IMPORTANT SAFETY RECALL
NHTSA Recall# 20V-551

Subject: Safety Tethers on units with Flat Bottom Floors

No.: B20012

Re.: Inspection and Repair of Safety Tethers
on units with Flat Bottom Floors

Tether Bolt Present

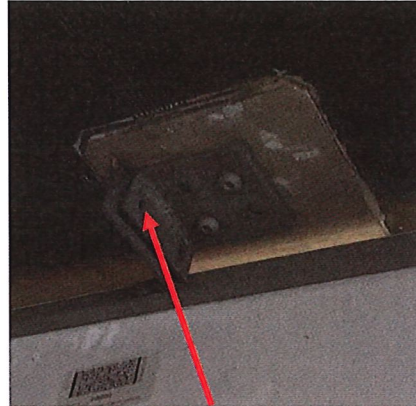
Inspection: An immediate inspection should be completed on all affected units to confirm that the bolts securing the two piece Safety Tether are present and secure. If these bolts are **not** present the unit should be taken out of service until the bolts have been replaced, or the instruction in this bulletin can be completed. It is preferred that this recall be completed in conjunction with campaign bulletin B20008 to reduce unit downtime. If the bolts are present the unit can remain in service, but it is recommended that the steps in this bulletin be completed as soon as practical.

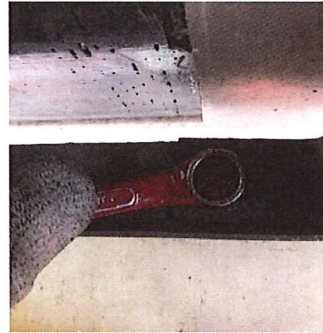
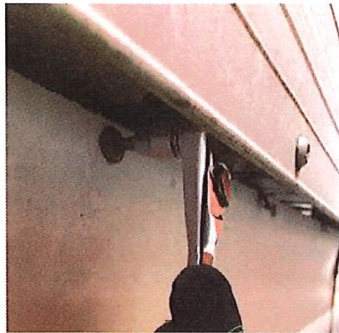
1. Remove the bolt and nut securing the Tether bracket to Skirt panel.

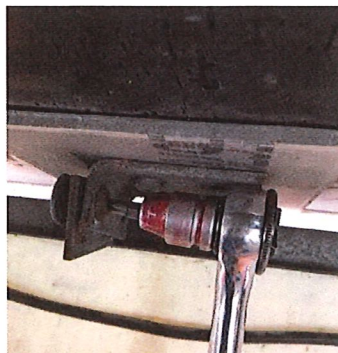
2. Remove the bolt and Tubular nut connecting the two pieces of the Tether assembly.

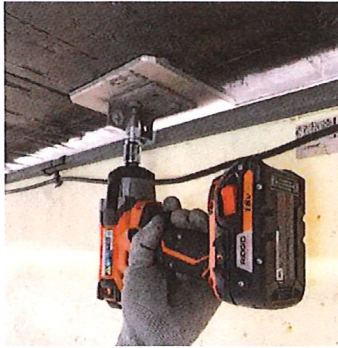
3. Remove the two bolts securing the Angle bracket portion of the Tether assembly to the bottom of the Flat floor. **Note:** It is not uncommon for these bolts to break during removal.

4. If one or both bolts break during removal, locate and mark the holes in the opposite diagonal mounting locations, and drill out for reassembly using a 9/32" Drill bit.

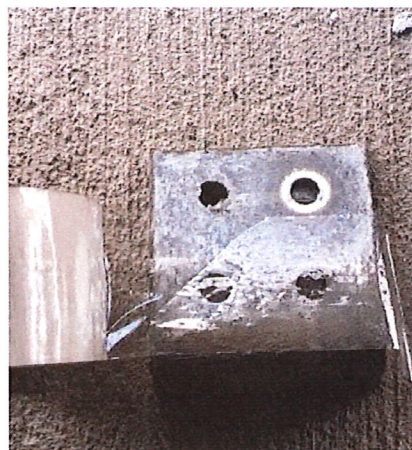
5. Apply Mylar tape to the mating surface of the Angle bracket portion of the Tether assembly.

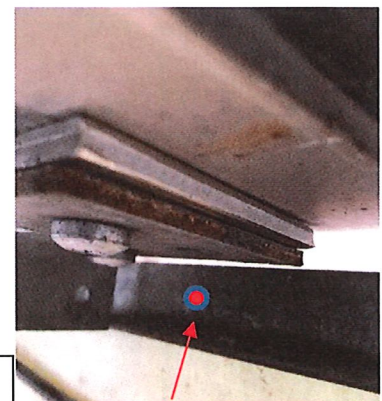
6. Position the provided ¼" Aluminum shim between the Angle bracket and the Aluminum plate on the bottom of the Flat floor.

7. Using bolt part number BLT00155 insert the bolts and tighten.

8. Rotate the secondary piece of the Tether assembly 180 degrees, locate for proper position, and mark for drilling new mounting hole.

Note: After rotating this portion of the assembly 180 degrees, the offset section should be pointing down vs. up as in its original location. This is to gain adequate clearance for the Free Floating assembly.

No Gap Here

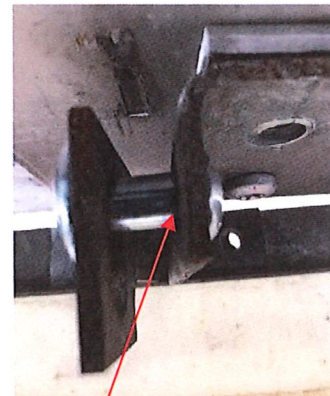
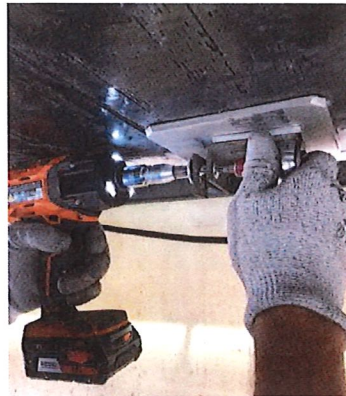
9. Install the new Tether bolt and nut. When tightening be sure that there is no gap between the Tubular nut, and the mating surface of Tether Angle bracket.

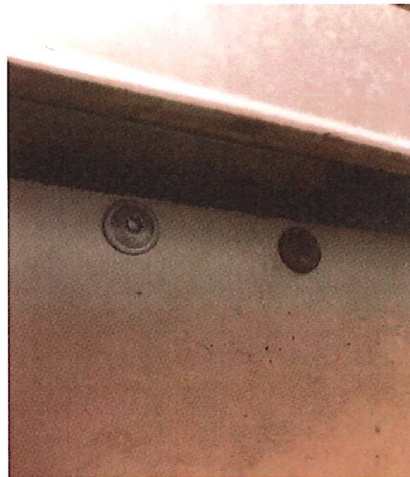
10. Finalize the repair by resecuring the Tether bracket to the Aerodynamic panel using the new provided bolt and nut, and fill the pre-existing hole with the original bolt and nut. Repeat these steps on all six Safety Tether assemblies. **Note:** It may be required to remove the front most panel on the roadside of the unit to gain full access to the Tether assembly in the area of Fuel tank.
